Access Compliance Report

Public Rights-of-Way

Intersection ID: 14999	Main Street: MONROE_RD	Cross Street: ALCOTT_DR	Location: SE
ADA ID: 990BDF80372F	Ramp Type: Perp	Initial Pass/Fail: Fail	Overall Compliance: No
		Severity Score: 35

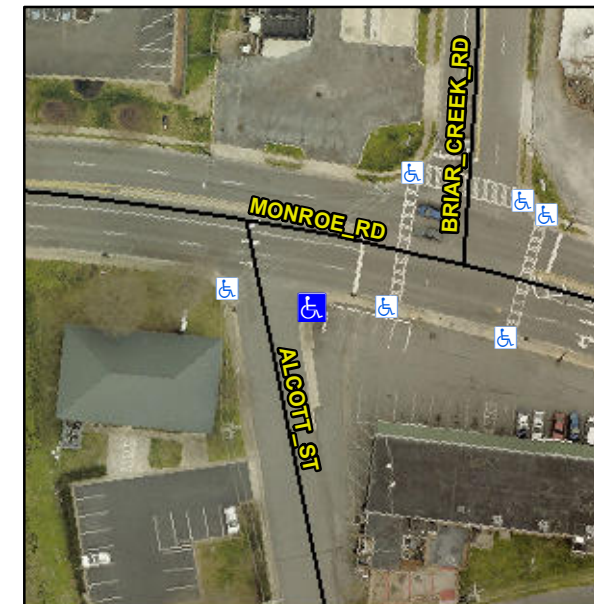
Not Found, R304.5.1, R304.2.2, R304.5.3

Compliance	Description	Data	Compliance	Description	Data
N/A	Ramp Length (in)	32.0	No	Ramp Slope (%)	13.7
No	Ramp Width (in)	39.0	No	Ramp XSlope (%)	2.7
N/A	Flare Type LT	N/A	N/A	Flare Type RT	N/A
N/A	Flare Slope LT (%)	N/A	N/A	Flare Slope RT (%)	N/A
N/A	Flare Traversable LT?	N/A	N/A	Flare Traversable RT?	N/A
N/A	Landing Length (in)	N/A	N/A	DWS Provided?	N/A
N/A	Landing Width (in)	N/A	N/A	DWS Contrast?	N/A
N/A	Landing Slope (%)	N/A	N/A	DWS Length (in)	N/A
N/A	Landing X Slope (%)	N/A	N/A	DWS Full Width?	N/A
N/A	Landing Curb? (Y/N)	N/A	N/A	DWS Offset (in)	N/A
N/A	Shared Landing?	N/A			
N/A	Gutter Ponding?	N/A	N/A	Gutter Slope (%)	N/A
N/A	Gutter Lip Ht (in)	N/A	N/A	Gutter X Slope (%)	N/A
N/A	Painted X Walk1?	No	N/A	Painted X Walk2?	N/A
	X Walk 1 Direction	To NW		X Walk 2 Direction	N/A
N/A	X Walk 1 Width (in)	N/A	N/A	X Walk 2 Width (in)	N/A
	X Walk 1 Slope (%)	1.5		X Walk 2 Slope (%)	N/A
	X Walk 1 X Slope (%)	3.0		X Walk 2 X Slope (%)	N/A

Remove & Replace Entire Ramp.
